Elephant and Castle Northern Roundabout Improvement Scheme

Stage 2 Road Safety Audit

Ref: 2209/008/A3/TLRN/2015

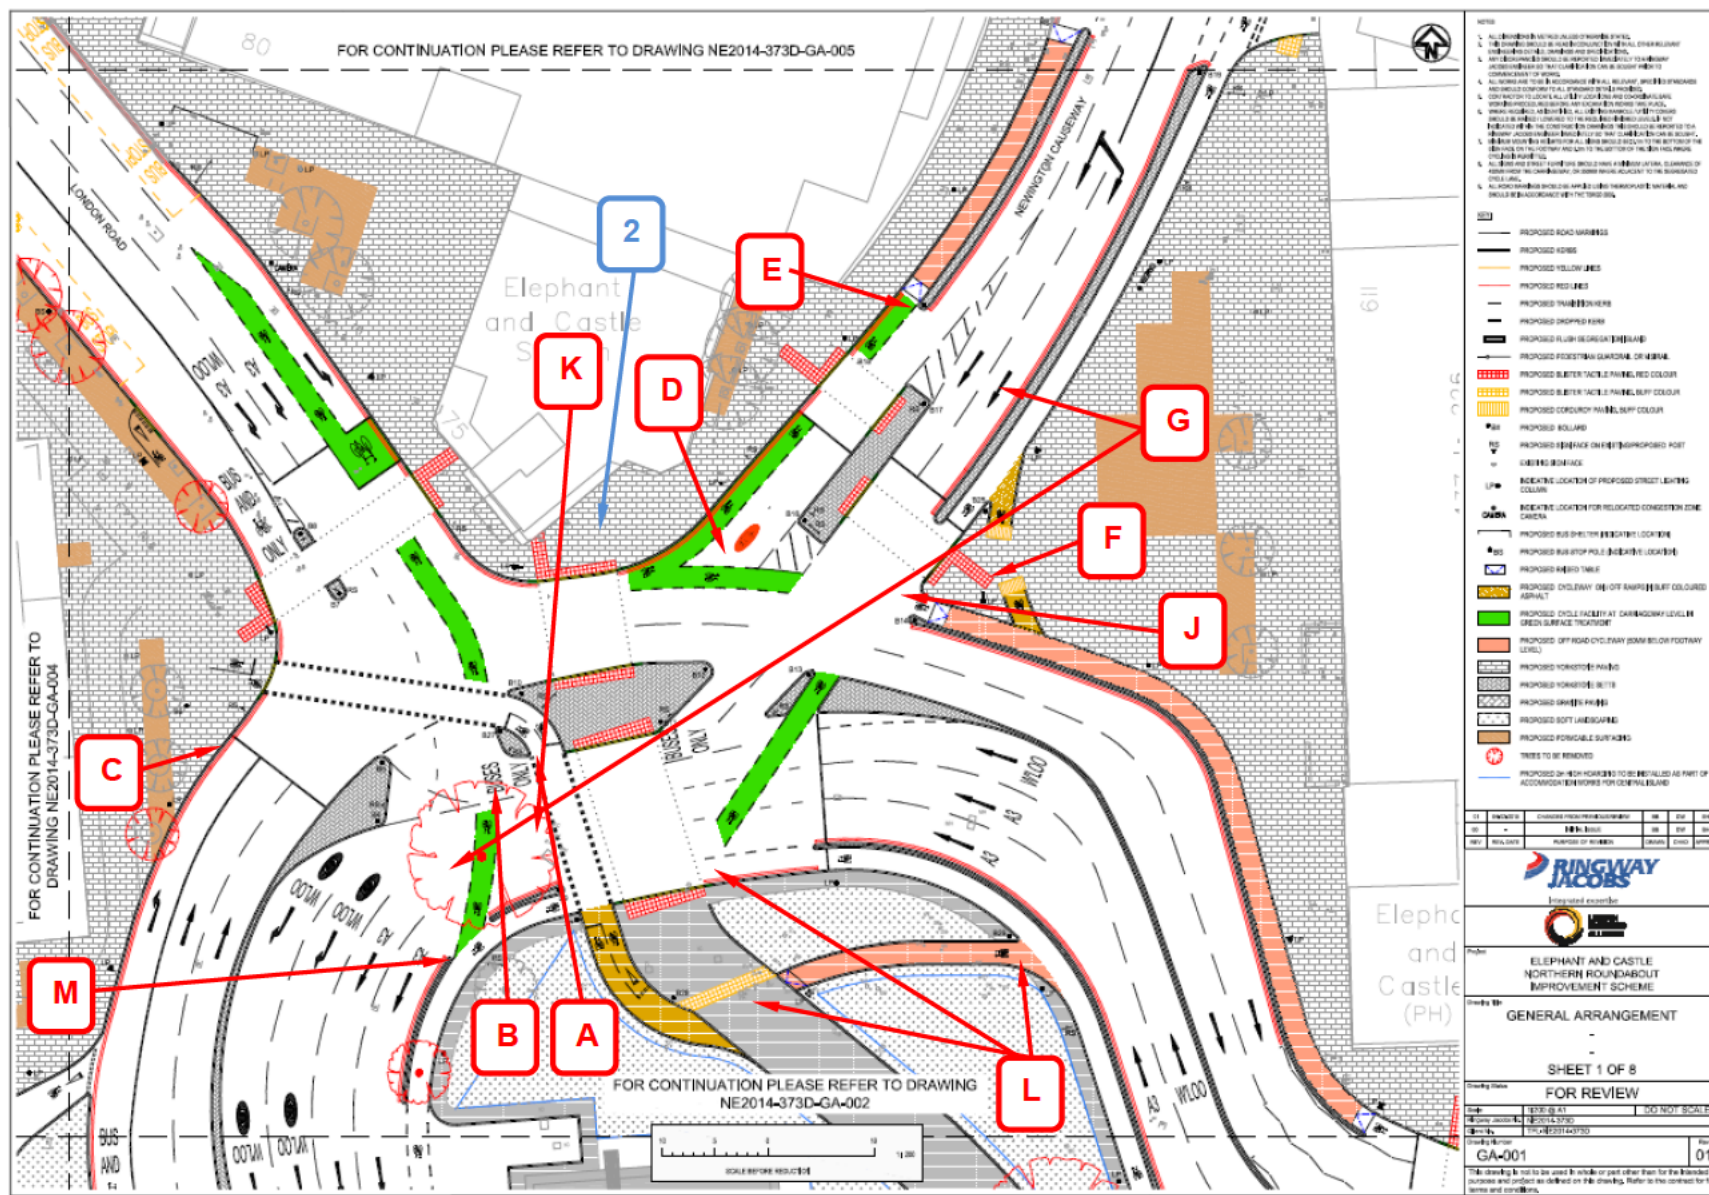
Summary: Proposed cycle stacking area may result in increased collisions between circulatory traffic and cyclists

The layout for the cycle lane which crosses from the inner to outer sides of the proposed Elephant and Castle peninsular, includes a two way controlled cycle crossing facility. The Audit Team are concerned that the area within the central reservation island may not provide suitable capacity to safely accommodate cyclists held on a red signal. This may lead to collisions as cyclists overhang into the carriageway, potentially into the path of circulatory traffic in either direction. If cyclists feel particularly vulnerable within this area, or do not realise that the crossing operates in two phases, they may be more likely to divert around the facility and/or disobey the red traffic signal with an increased potential for collisions with circulatory vehicles as they attempt to cross three traffic lanes potentially out of phase.

Summary: Proposed 'buses only' right turn facility is uncontrolled and may result in collisions with cyclists using the controlled cycle crossing facility.

The proposals include an uncontrolled right turn facility to facilitate buses turning right onto London Road within this otherwise signal controlled junction. The Audit Team have concerns that a non-controlled traffic flow within an otherwise controlled junction may increase the risk of collisions as opposing flows are not completely separated. Specifically the Audit Team have concerns that buses turning right from this facility may:-

Summary: Proposed left turn only nearside Bus and Cycle lane may result in increased risk of collisions with cyclists continuing ahead.

Summary: Users may attempt to exit in two lanes which may result in increased 'side swipe' type collisions.

Summary: Layout on approach to the physical island which segregates the cycle lane and general traffic lane may result in collisions with the feature.

Summary: Location of pedestrian crossing and cycle by-pass may result in collisions between pedestrian and cyclists.

Location: G – Newington Causeway approach to proposed Peninsular.
Summary: Increased side swipe type collisions may result from poor lane discipline.

Summary: Cycle lane layout across the access may result in cycle collisions.

Summary: Cycle lane layout and proximity to bus stop may result in increased cycle / bus collisions as they attempt to cross one another's path.

Summary: Left turn ban may encourage unsafe turning manoeuvres

Design Organisation Response	Accepted / Part Accepted / Rejected
<p>RJ raised issue in Design Query Register, which was issued to TfL for review and response. Meetings with TfL also took place to discuss issue.</p> <p>TfL stated that traffic signal modification cannot be considered as it will have a network impact which will impact on the approved and signed off TSSR.</p> <p>A design change has now been made to make this cycle route one way northbound effectively doubling capacity for cyclists in the waiting area on the island.</p>	
Client Organisation Comments	
<p>A refinement of the design has been introduced to make the cycle crossing towards London Road one-way only, therefore effectively doubling the capacity for waiting cyclists.</p> <p>Although this design could cater for cyclists in both directions in future, the large majority of users would be cyclists in the morning peak hours from New Kent Road travelling towards Cycle Superhighway 6. The signal phasing at this location avoids keeping cyclists waiting in this location, and the signal timings dictate that the next phase allows cyclists who are on the island to move off northwards towards London Road should any stacking back into the carriageway. The junction will be monitored after implementation to ensure it is effectively clearing all cyclists.</p> <p>Currently flows of cyclists in the AM Peak westbound are 312 in the peak hour, with a maximum of 90 cyclists in any one 15 minute period. On a cycle time of 120 seconds there should be no more than 12 cyclists in the island area at any one time, or 17 including a projected 40% future uplift. This assumes however that all cyclists</p>

Design Organisation Response	Accepted / Part Accepted / Rejected
RJ raised issue in Design Query Register, which was issued to TfL for review and response. Meetings with TfL also took place to discuss issue.	
TfL stated that traffic signal modification should not be amended as it will have a significant network impact which will impact on the approved and signed off TSSR.	
TI were consulted regarding this issue and they stated that they expect that right-

Design Organisation Response	Accepted / Part Accepted / Rejected
RJ had meeting with TfL to discuss the concerns regarding the proposed turning movement for the buses into London Road. TfL reiterated response from RSA 1 stating that the bus lane has been designed to a width which makes it almost impossible cyclists & buses to pass each other thereby promoting cyclists to adopt a central dominant position in the lane. Initial VISSIM modelling results have shown only two or three buses make this manoeuvre each cycle. In addition, the problem is further lessened as buses will be familiar with the situation as a daily occurrence and during peak periods large numbers of cyclists will be present and adopt a presence in the bus lane. RJ support this response.	
Client Organisation Comments	
The latest cycle guidance has advised the removal of the cycle marking at the entrance to St George's Road.	
Preventing the overtaking of cyclists with a narrower bus lane is considered to be the lowest risk approach which can be accommodated through this junction. It puts cyclists in the dominant position.

Design Organisation Response	Accepted / Part Accepted / Rejected
<p>Advanced signing has been proposed notifying motorists of the permitted movements and destinations to assist with motorists advanced lane decision.</p> <p>There are carriageway layout constraints for implementing advanced road marking directional arrows, due to proposed controlled crossing location.</p> <p>RJ to include text destinations to supplement straight ahead arrows for clockwise lanes.</p>	
Client Organisation Comments	
<p>Agree with Designer's response. This will be monitored further at RSA3 to agree any further road markings to reduce lane changes.</p>

Design Organisation Response	Accepted / Part Accepted / Rejected
RJ amended concept design to reduce segregated island length. This was done to mitigate the need for a temporary road closure to address any potential future maintenance works of the front end of the segregation island e.g. replacing a 'Jilson' TSRGD bollard (black & white), which has been proposed by RJ at the entry point of segregated cycle lane. RJ to implement road marking hatch on approach to segregated island, as per recommendation.	
Client Organisation Comments	
Agree with Designer's response.

Design Organisation Response	Accepted / Part Accepted / Rejected
1. Design is as per the concept design. Decluttering is a key deliverable of the concept design. Perceived issue noted and recommendation to monitor after scheme implementation and mitigation measure to be considered if conflict issue develops.	
2. Design is as per the concept design. RJ raised issue in Design Query Register, which was issued to TfL for review and response. Meetings with TfL also took place to discuss issue. RJ made surface material changes as part of detailed design but this has now been rejected by TfL following objection from WWM and design has now reverted back to TfL concept design as per TfL's instruction.

Design Organisation Response	Accepted / Part Accepted / Rejected
RJ to supplement nearside lane road marking arrow with text 'A3 ONLY'. Additional signage to be considered if possible.	
Client Organisation Comments	
Agree with Designer's response.

Design Organisation Response	Accepted / Part Accepted / Rejected
Design is as per the concept design with the exception of changes to the road marking layout, which was agreed with TfL via Design Query Register process.	
Visibility for exiting vehicles not considered an issue. Agreed that visibility for vehicles entering is affected by presence of buses waiting and passengers boarding/alighting. Vehicle entering speeds anticipated to be low.	
Meetings with TfL also took place to discuss issue and TfL stated that options for relocation of bus stop not possible due proximity of existing bus stop further north and impact on approach lane capacity further south.	
Instruction from TfL was for no change to floating bus stop layout in concept design.	
RJ recommend for issue to be monitored after scheme implementation.	
Client Organisation Comments	
Bus stop bypass provides additional safety benefits for cyclists and the vast majority of vehicles using the access into the Metro Central Heights development will be repeat users who are familiar with the layout. Vehicle flows are very low at this location and cyclists have good sight lines approaching the access road.

Design Organisation Response	Accepted / Part Accepted / Rejected
RJ raised issue in Design Query Register, which was issued to TfL for review and response. Meetings with TfL also took place to discuss issue.	
RJ enquired if a similar floating bus stop design as per southbound carriageway had been explored. TfL stated that this design was not possible due to physical constraints, and the removal of significant established trees required.	
RJ enquired if bus stop could be proposed further north on exit side of the controlled crossing. TfL stated that this was not possible, as bus stop needed to be no further than existing location for passenger demand/accessibility.	
RJ to consider additional cycle symbols (Diag. 1057) to further highlight this potential conflict location.

Design Organisation Response	Accepted / Part Accepted / Rejected
<p>As per RSA1 TfL response, advanced signing has been proposed notifying motorists of the permitted movements at the junction to avoid motorists from arriving at the junction and undertaking illegal or u-turn manoeuvres.</p> <p>The perceived issue will be monitored for this new road layout but essentially this is an issue for enforcement.</p>	
Client Organisation Comments	
<p>Vehicle flows for this movement are so low that they cannot be accounted for on the traffic modelling software. There is sufficient space capacity on Great Dover Street which is the direct route.</p> <p>Vehicle counts have also been completed within the Rockingham Estate to enable further monitoring after the works have been completed in case there is an impact from an increase in vehicle traffic.</p>
